PROJECT #CC20-065 RUNWAY 17/35 RECONSTRUCTION PHASE III

September 24, 2020

ADDENDUM 2

SCLA AWOS RELOCATION

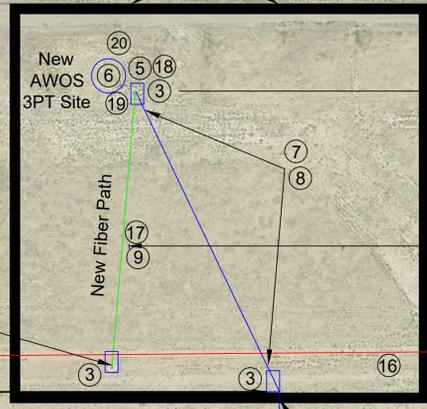
8. QUESTION: There are no drawings or details for the AWOS Bid Schedule 300.

ANSWER: The plans and specifications for the AWOS Bid Proposal Price Schedule 300 were inadvertently omitted. They are included with this Addendum.

- i. The scope of work contemplated for the AOWS under Bid Proposal Price Schedule 300 is depicted on the single drawing entitled "SCLA AWOS Relocation" and described in the "AWOS Relocation Scope of Work". FAA Advisory Circular AC150-5220-16E *AWOS for Non-Fed Applications* and two Corning fiber optic specification sheets provide additional guidance. The aforementioned documents, sans the Advisory Circular, are attached hereto and labeled "Addendum 2".
- ii. Aside from the AWOS work in Item i above, the single drawing entitled "SCLA AWOS Relocation" provides graphic guidance for relocation of other navigational aids that are represented in Bid Proposal Price Schedule 200.
